Order Number:	CPO 0310 6377 DNR2000000012 7	Procurement Folder:	697731
Document Name:	Bowden Hatchery 3 - New Facilities Construction	Reason for Modification:	Change Order No. 05 to extend and increase the contract per the attached documentation.
Document Description:	Change Order No. 05- Bowden Hatchery 3- New Facilities Const		
Procurement Type:	Central Purchase Order		
Buyer Name:	Joseph E Hager III		
Telephone:	(304) 558-2306		
Email:	joseph.e.hageriii@wv.gov		
Shipping Method:	Best Way	Effective Start Date:	2020-08-31
Free on Board:	FOB Dest, Freight Prepaid	Effective End Date:	2022-07-29

Re: Change Order No. 5
Bowden Fish Hatchery
Contract 3 – New Facilities
CPO 0310 6377
DNR 2000000012

CHANGE ORDER INFORMATION:
Change Order Number: 005

Bowden Hatchery Improvements
Contract 3
Attachment to Change Order 5

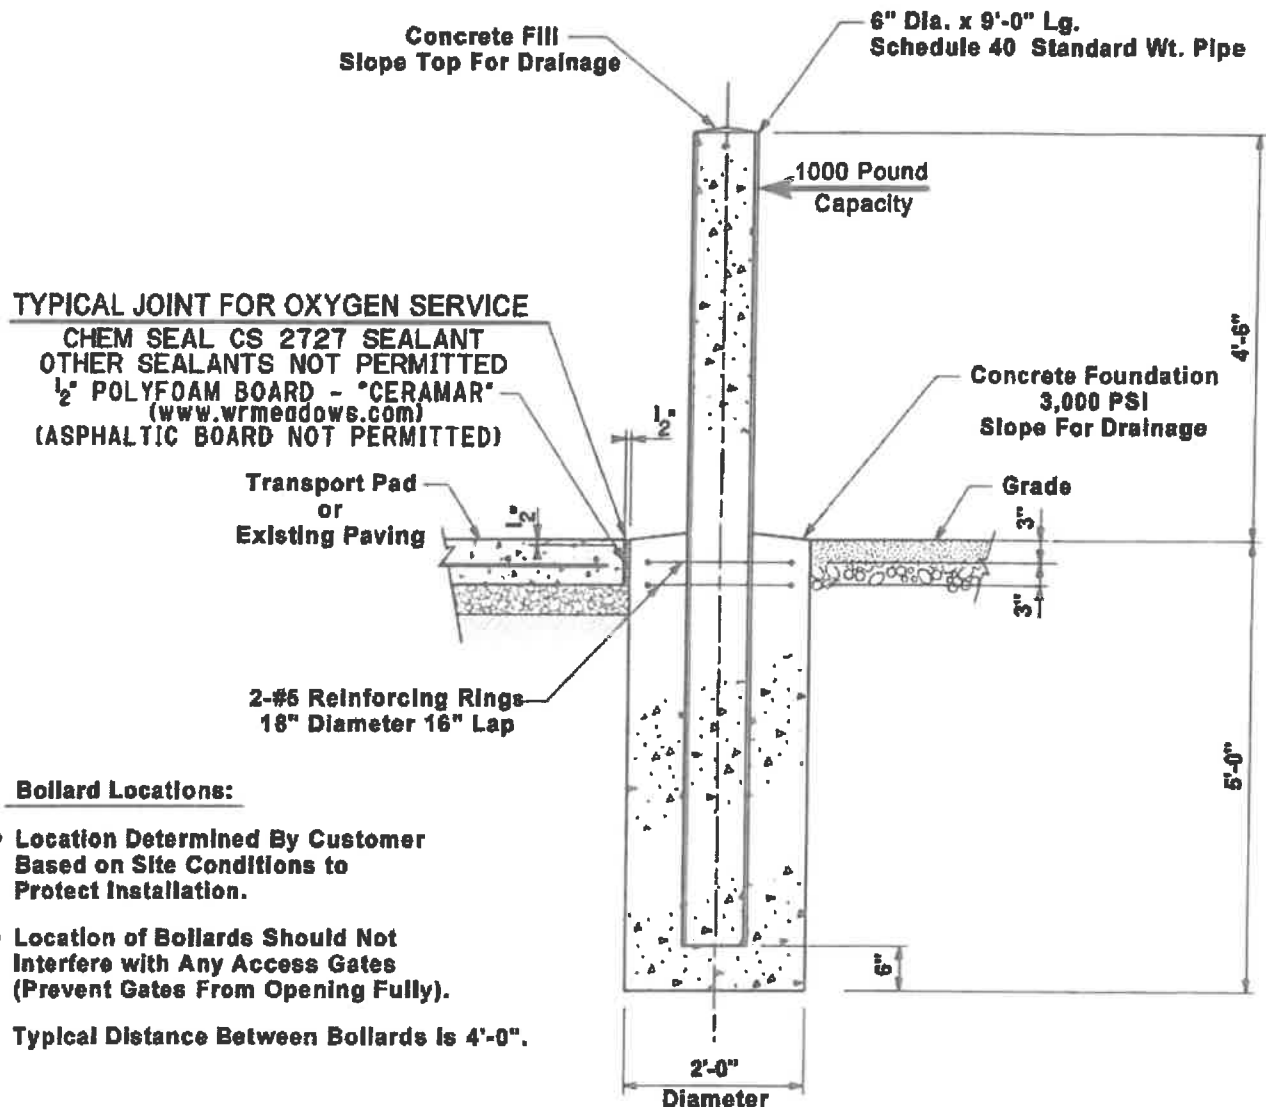
1. Do you want 6" pipe bollards as labeled on your revised dwg or 4" pipe bollards (per the std bollard detail on stf-det-01 which you sent us previously)? See attached.

2. Per our discussion, bollards are required at all approachable sides, so they will need to be on all 4 sides Correct
3. Do you want the 6' high chainlink fence between the pad and bollards as shown on the revised dwg you just sent? Or do you want the 6' h fence on top of the pad, 6" from the edge of the pad per the plan tank pad detail on stf-atm-001 (which you sent us previously). Dealers choice on the fence mounting. You can mount on the pad edge, or move it out up to 6" from the pad completely.

4. Our impression is that we are only stubbing up 1 ea – 1" pipe beside of the pad. And that you all will tie into that with your plumbing / piping from the tanks and also will be providing the valves. Is this correct? The valves act as the TOP for Airgas and Bowden. Bowden will own the valves, this provides a clean line of ownership as well as process control from the customer side.

COP 30
Locatn Sketch
08/11/21

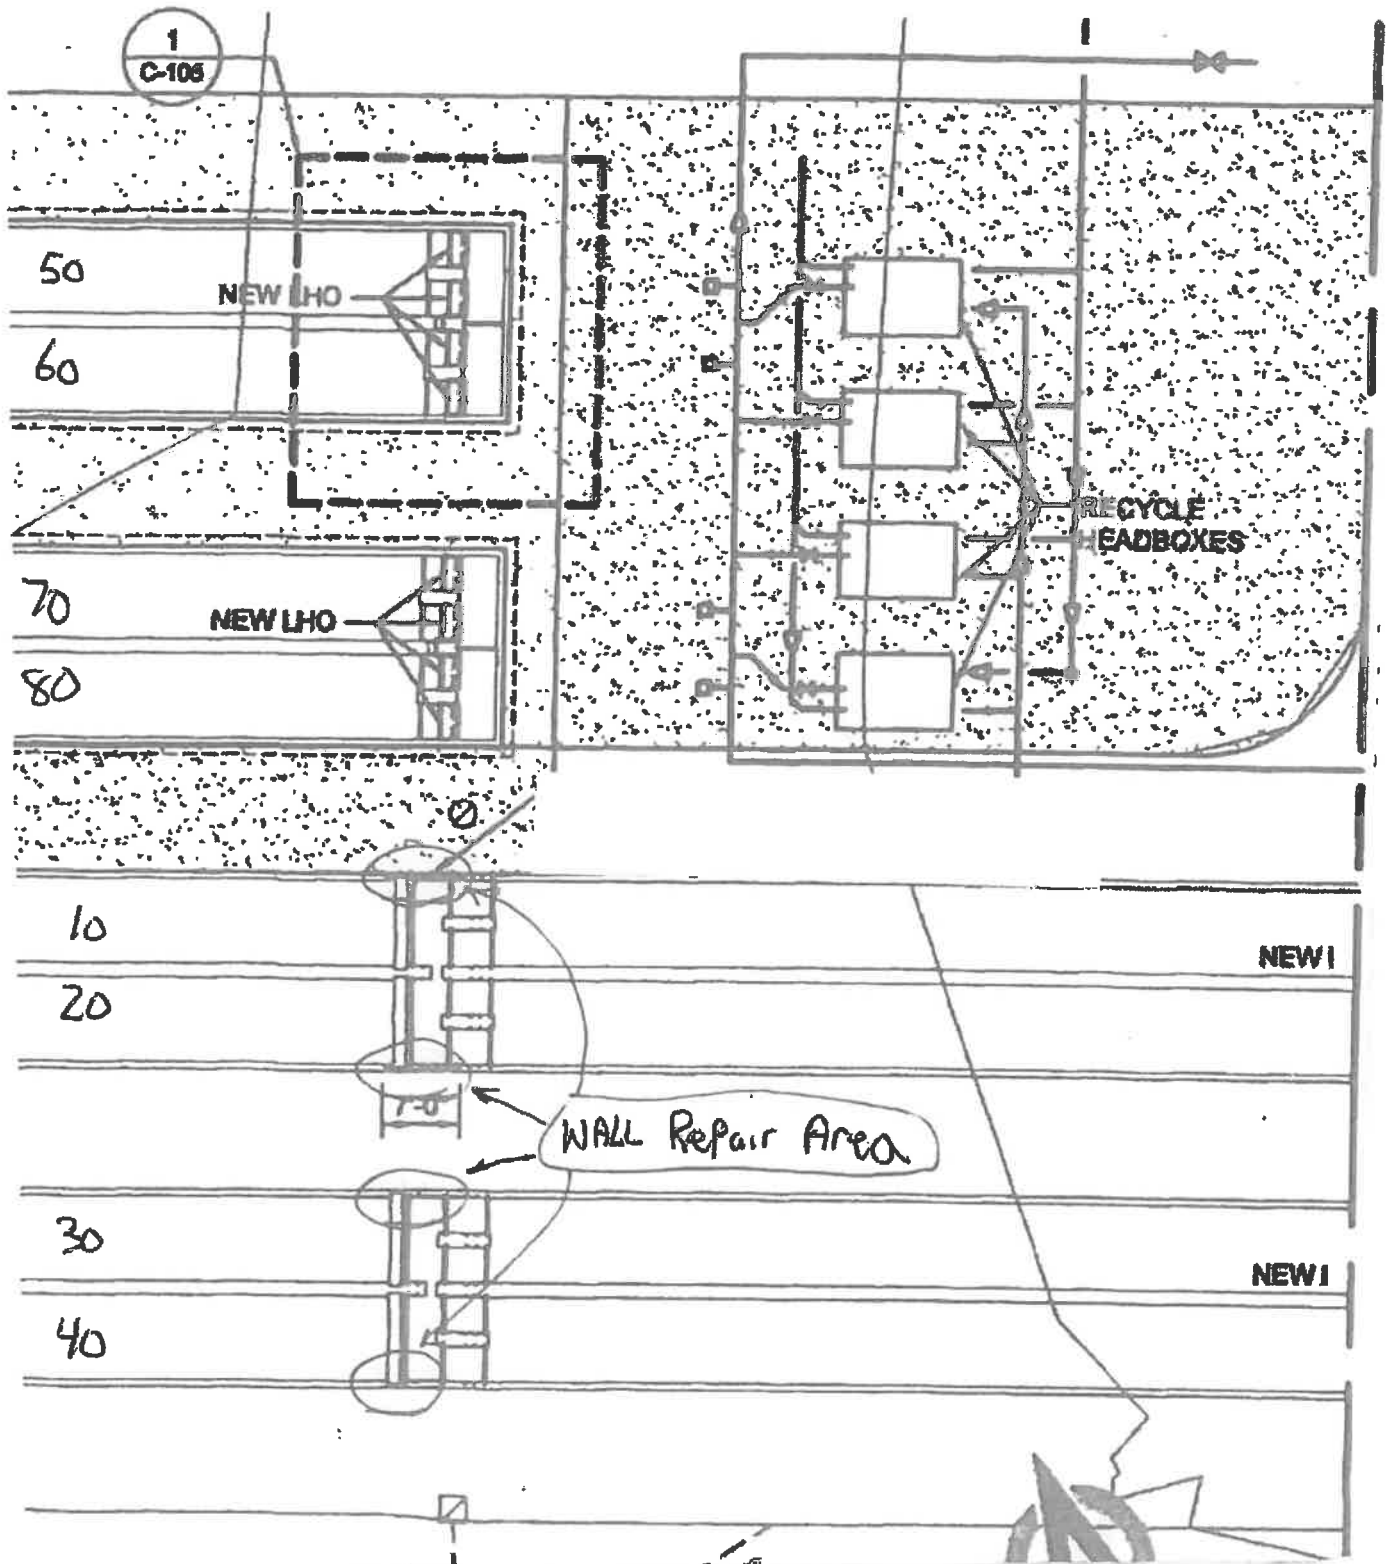
As per your request, we are pleased to provide the following change order proposal for removing and replacing 4 ea - approx 7' +/- long x 3' +/- high x 8" thick concrete wall sections at existing raceways 10-40 (see attached sketch for locations). This work will be performed according to the wall repair detail on C-108 (except we will go from top of wall to as close to the slab as we can (approx 3ft).

COP 31
Sketch 9/9/21

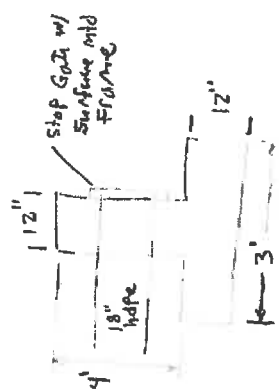
As requested, we are pleased to provide the following change order proposal to add an 18" ads hdpe storm drain between Ponds 1&2 (including concrete walls at each end with 30" x 30" aluminum stop plates with surface mounted guides) and an 18" ads hdpe storm drain between pond 1 and an existing drop inlet (including a concrete wall with 30" x 30" aluminum stop plates with surface mounted guides at Pond 1). (see attached sketch for more info)
